REGIONAL REVIEW NOTIFICATION

ARC REVIEW CODE: R809291

Name of Proposal: Riverview

Preliminary Report:	September 29, 2008	DEVELOPMENT OF REGIONAL IMPACT REVIEW REPORT	Project:	Riverview # 1933
Final Report Due:	October 29, 2008		Comments Due By:	October 13, 2008

DRI SITE PLAN (DRI ID: 1933)

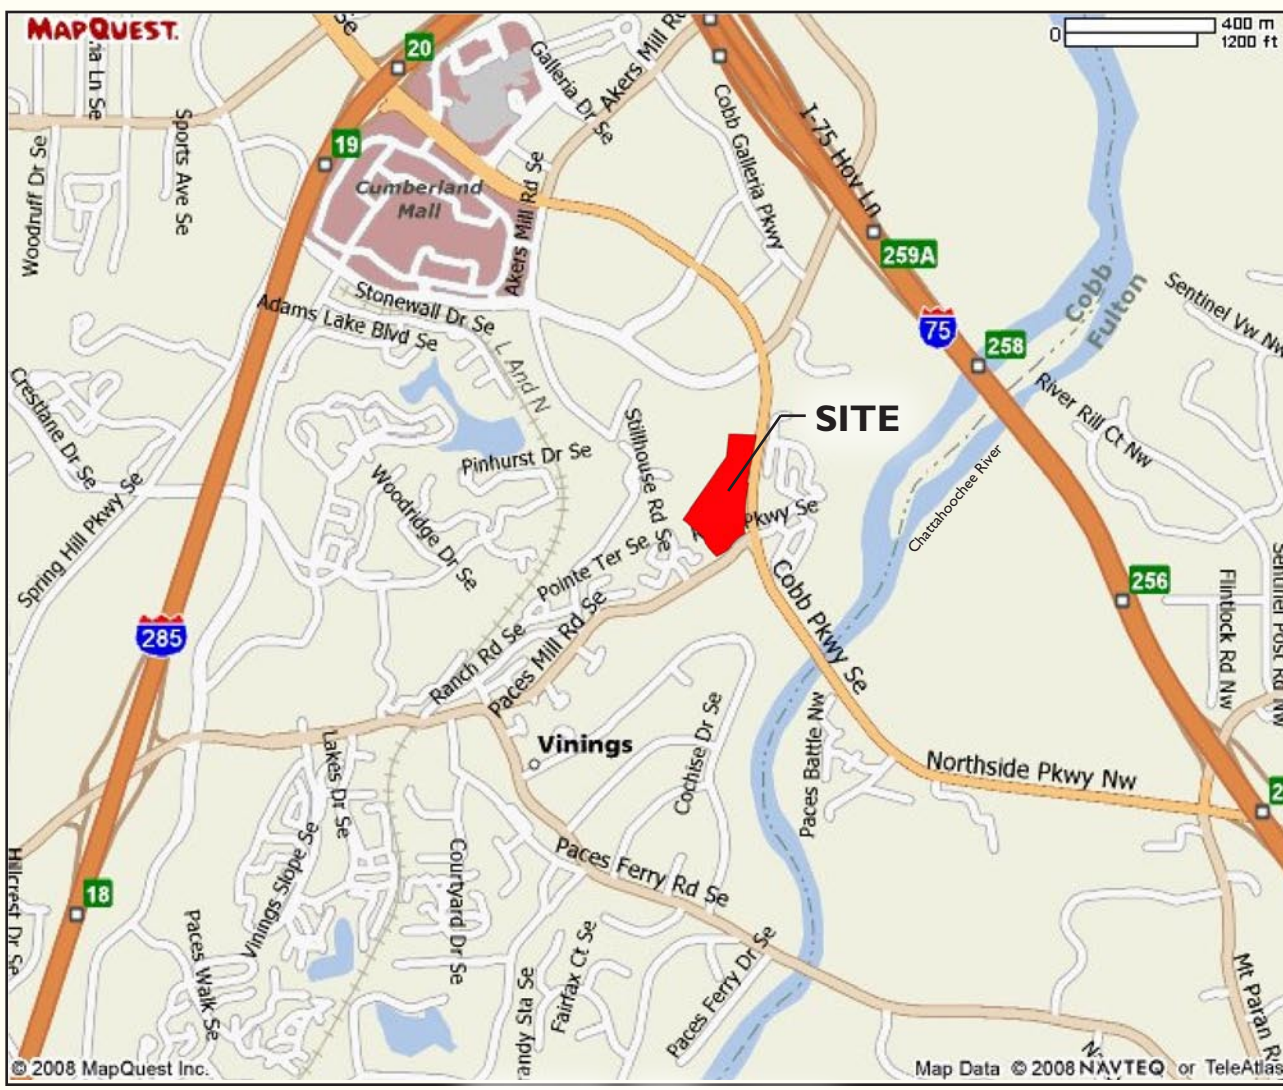
No streams are located on the project property, as shown on the regional USGS coverage and the original project plans. However, a stream does run adjacent to the property and the required Cobb County buffers are shown.
